Leigh Anne and Phil Francis
Comments on Cork Screw Ramps

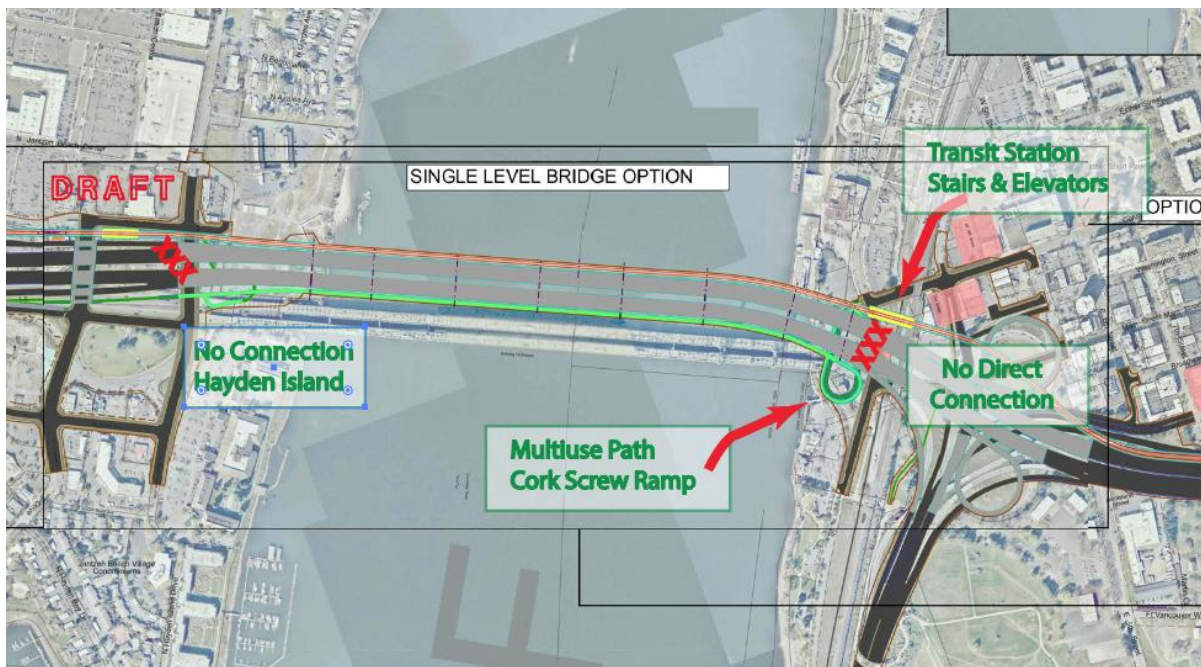
The IBR proposes building the light rail line on the south bound main bridge. The Vancouver shoreline light Rail Station is approximately 100' in elevation above the ground and is access through stairs and elevators.

The multiuse path is built on the north bound main bridge span. The end point of the multiuse path on the Vancouver shoreline is approximately 100' in elevation above the ground and is access by a cork screw ramp of approx. ½ mile in length.

Though the Vancouver shoreline Light Rail Station and the end point of the Multiuse Trail are adjacent to each other and are both 100' in elevation above the ground, the access systems for each are entirely separate from each other. The stairs and elevators for transit users are not usable for users of the multiuse path. The ramp connection for multiuse path users that are not usable for transit riders.

The Hayden Island light rail station and Oregon side of the main bridge multiuse path has the same disconnection, though the elevation is less at about 35' above ground.

People who are not driving to their destination, a goal of the IBR, will often use several modes to reach their destination. Users may ride their bikes to a light rail station, place their bikes on the train in storage specially design for bikes on the light rail train, then ride their bikes for the final leg of their trip. The IBR design of entirely separate light rail and multiuse path access makes these blended trips difficult.

We believe additional study is needed to connect these two systems together.
